City of MISSION

PLANNING COMMISSION

AGENDA

STAFF REPORT
Planning Commission Meeting September 25, 2017

PROPOSED FLOOD PLAIN PLAN

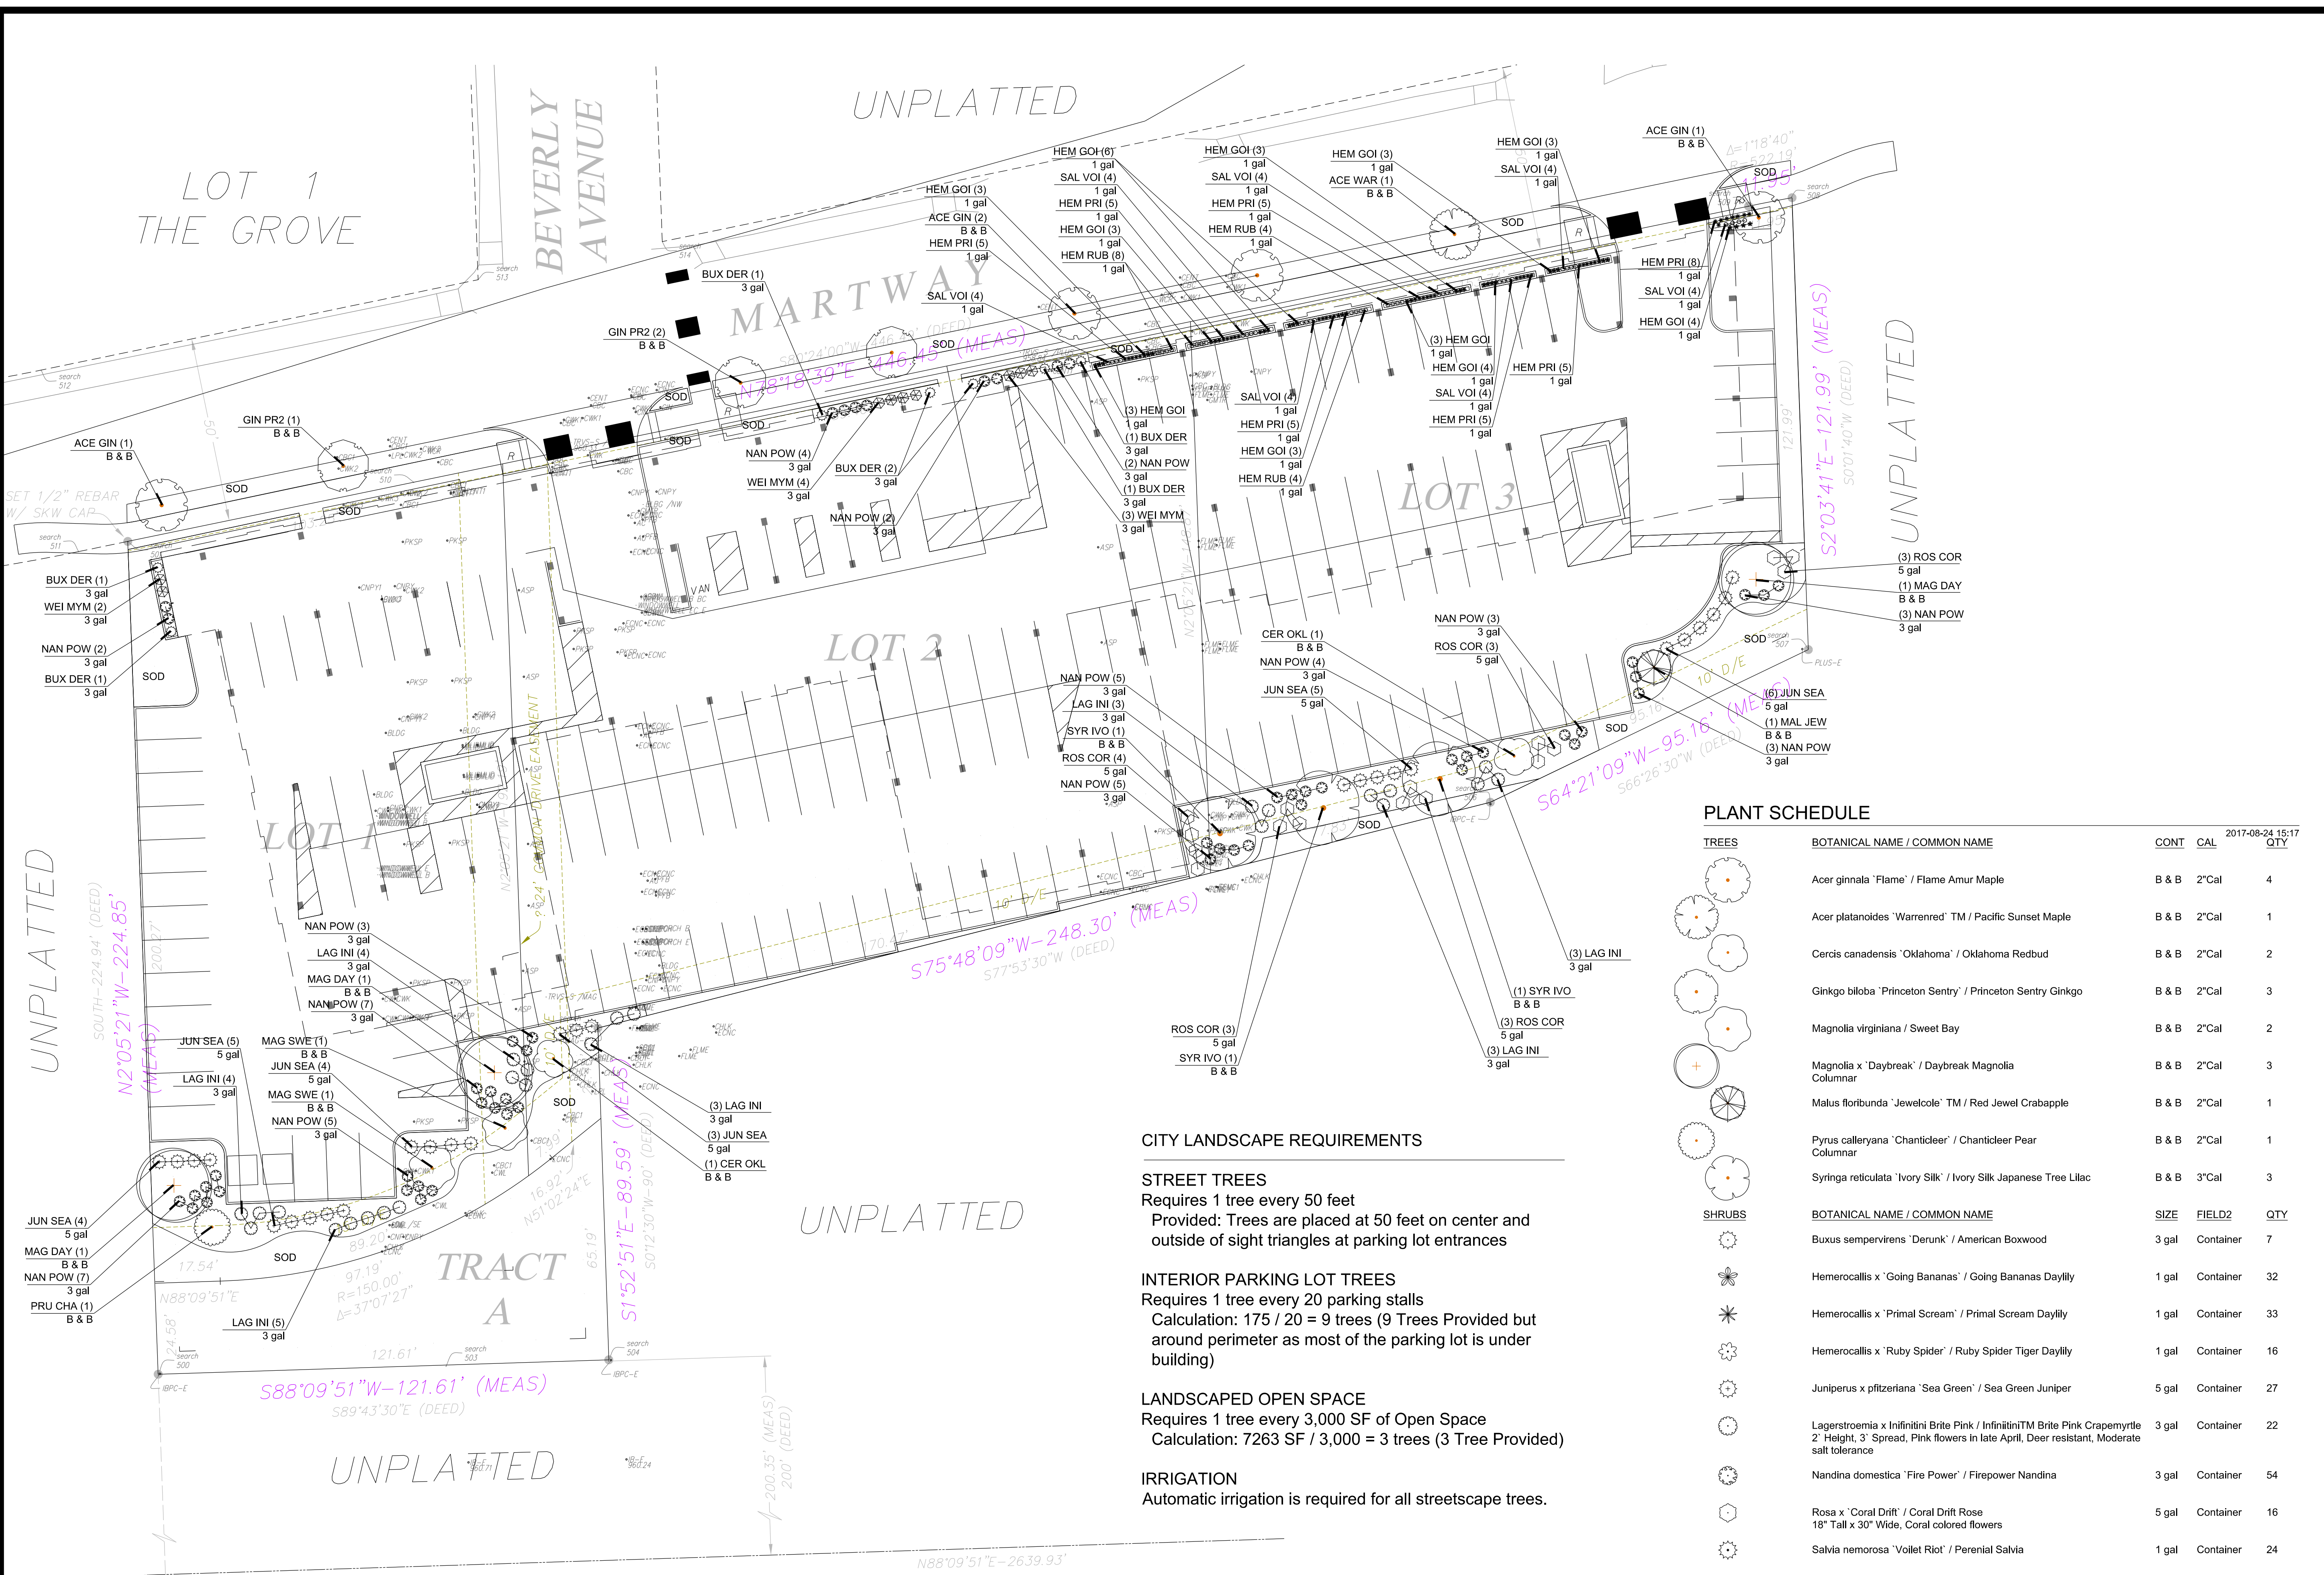
The 100 year floodplain limits over parking lot have been shown on Sheet C-203, Proposed Floodplain Plan. The parking lot has been graded such that no parking stall would pond over 7" based on the FEMA floodplain depths.

Both the traffic study and the drainage memo has been updated to address parking lot ponding. The 100 year floodplain limits over parking lot have been shown on Sheet C-203, Proposed Floodplain Plan. The parking lot has been graded such that no parking stall would pond over 7" based on the FEMA floodplain depths.

professional seal
drawing title ARCHITECTURAL ELEVATIONS
drawing number **A 00**

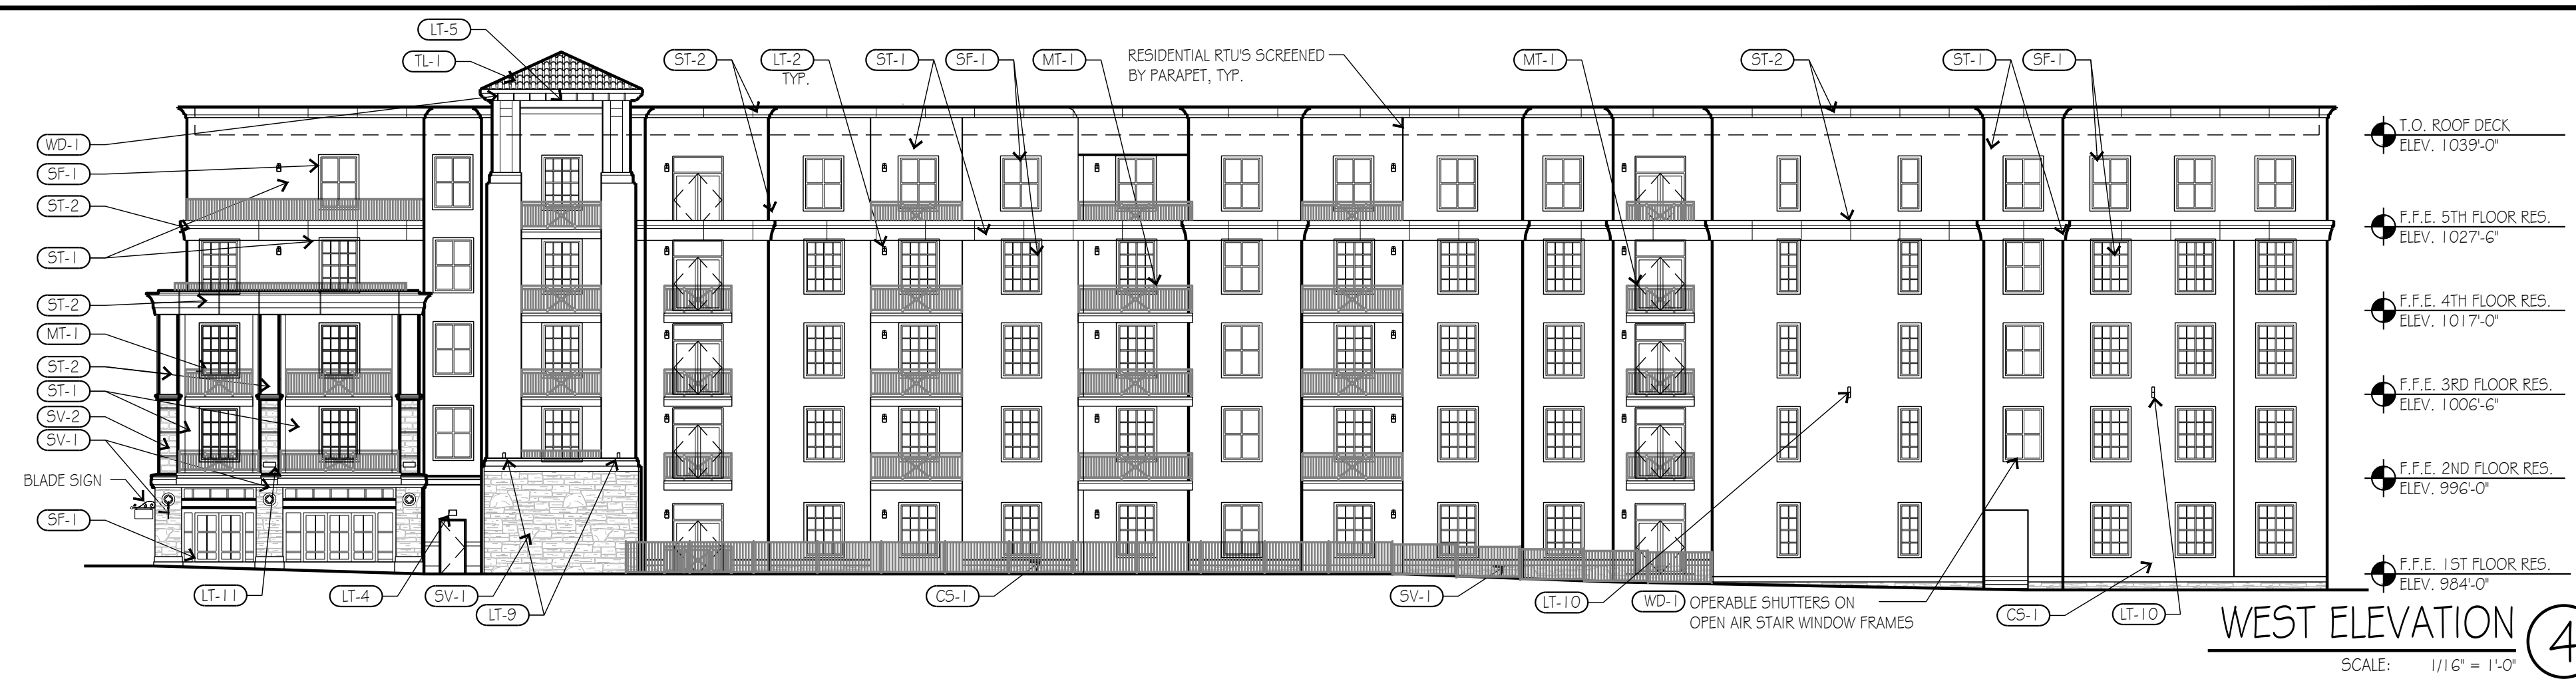
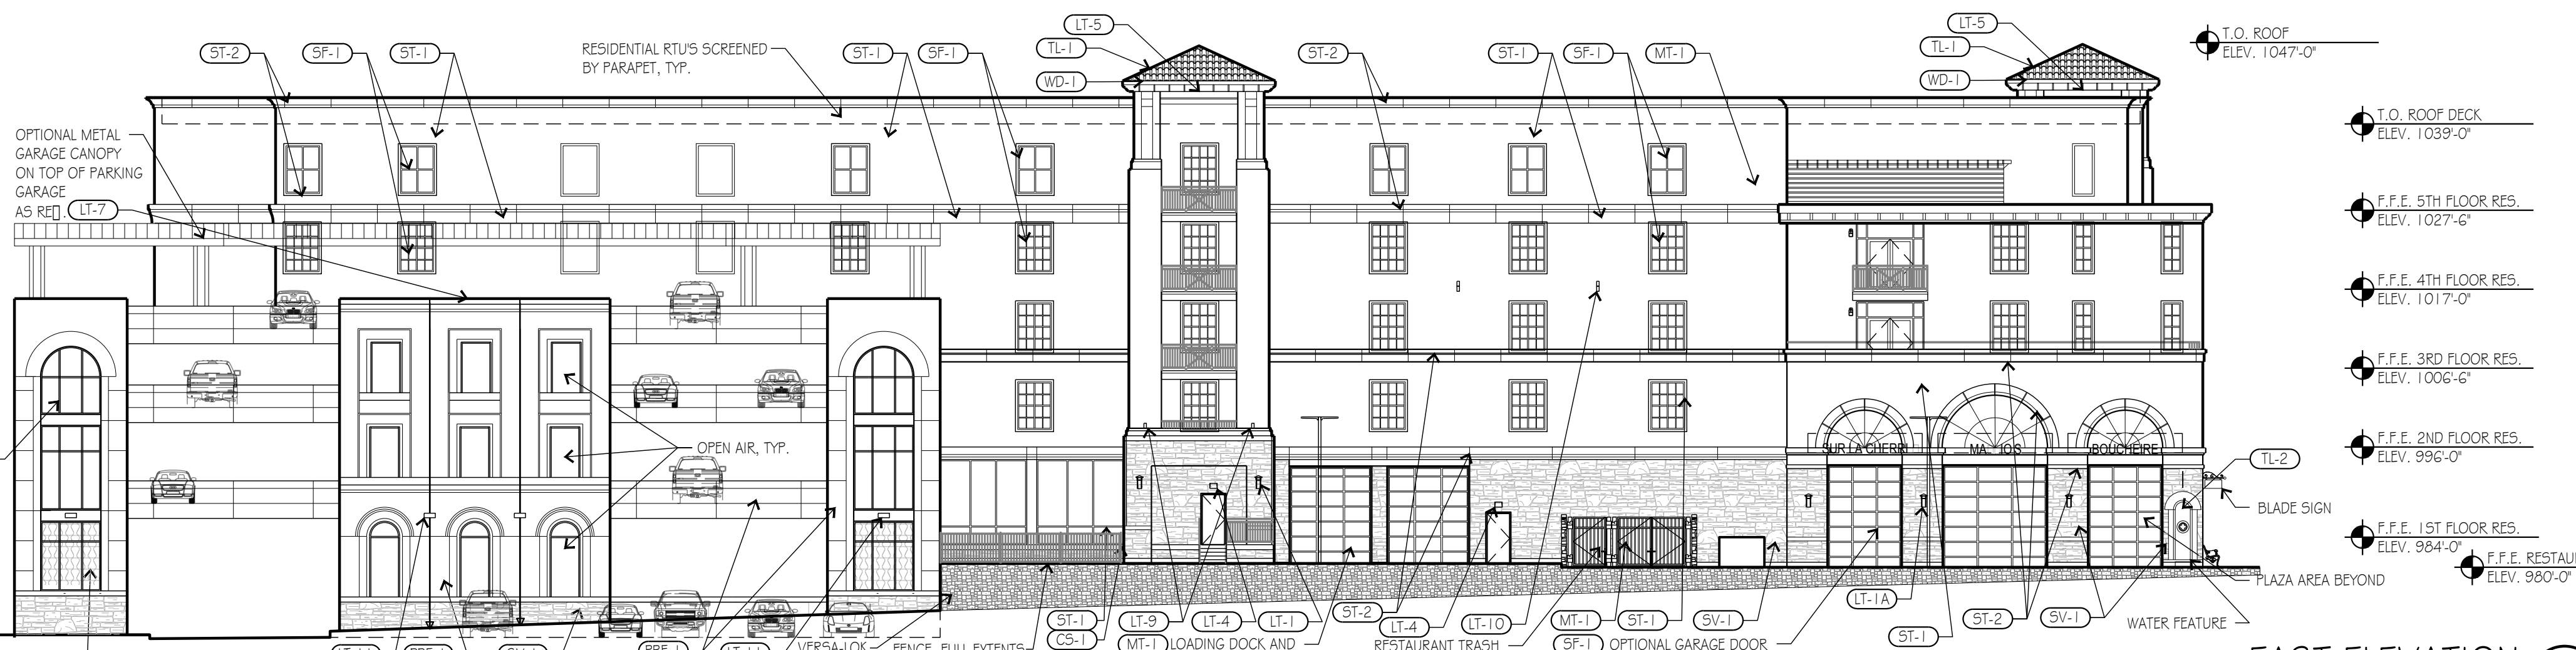
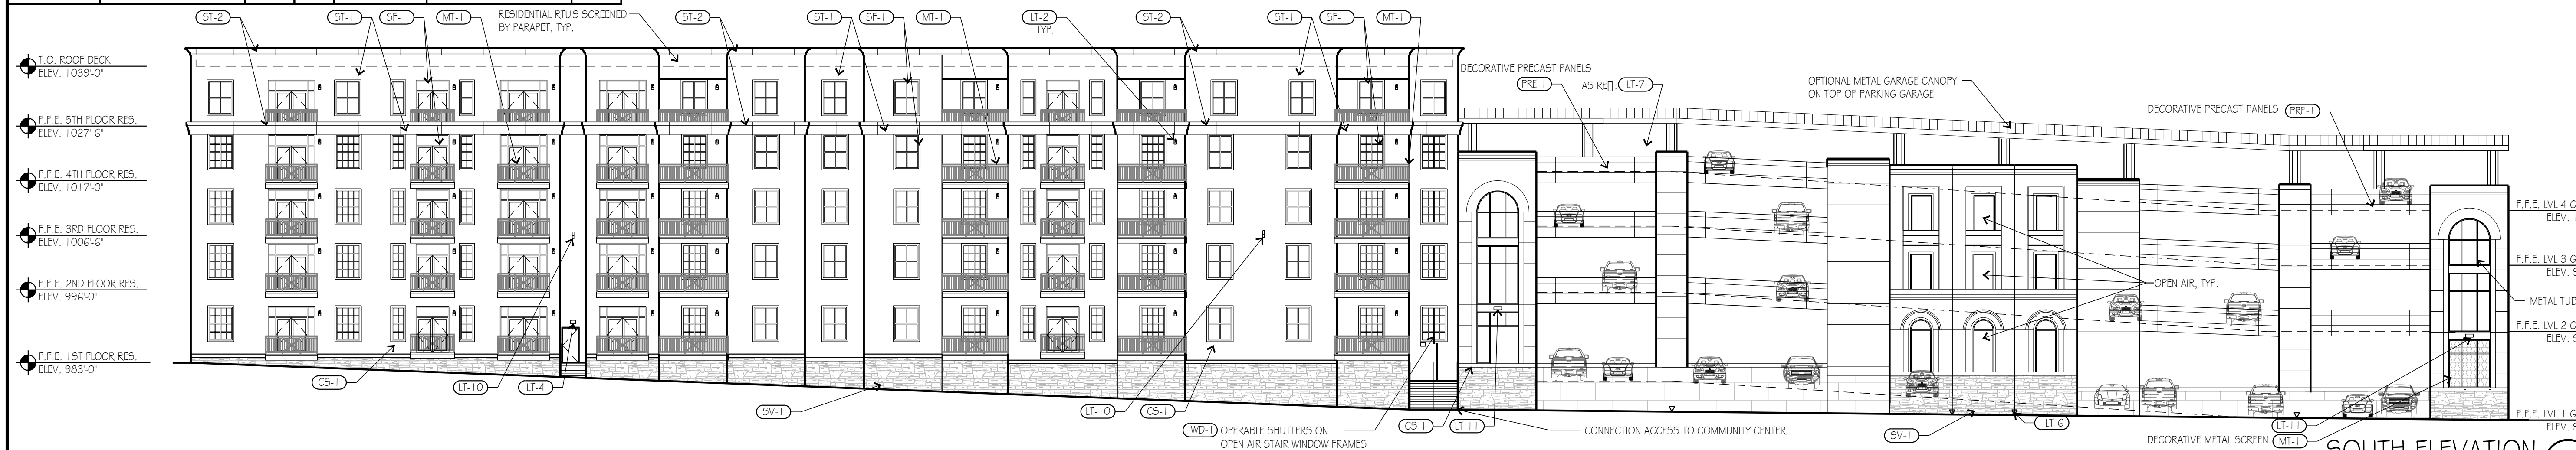
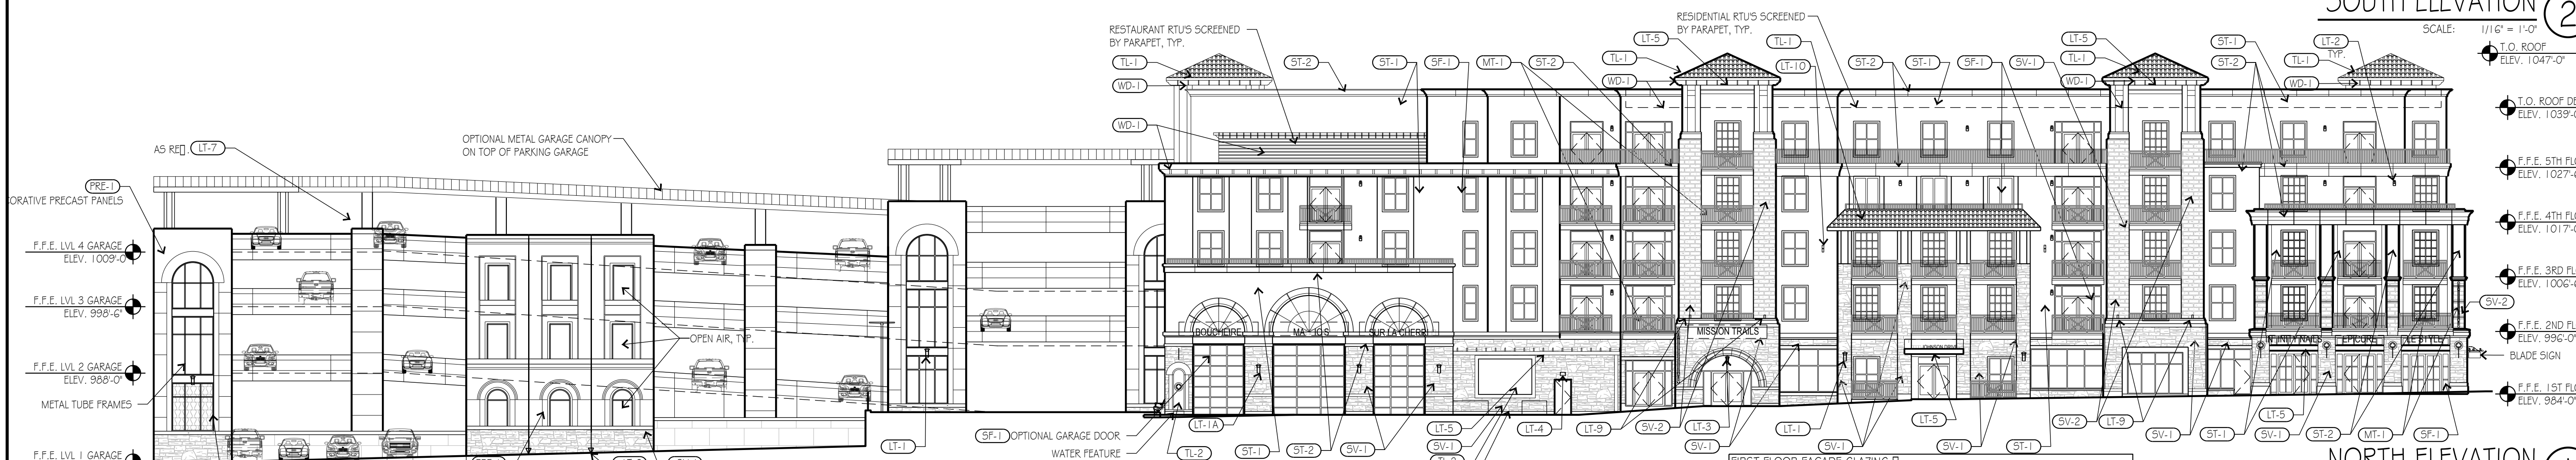
- *See Revised Sheet A200 with façade material calculations per previous discussions with city and deviations.*

- *See Revised Sheet A200 with dashed in vehicle profiles. Vehicles are highly obscured from view from public streets.*

- *See Revised Sheet A200 showing display windows elevated above sidewalks.*
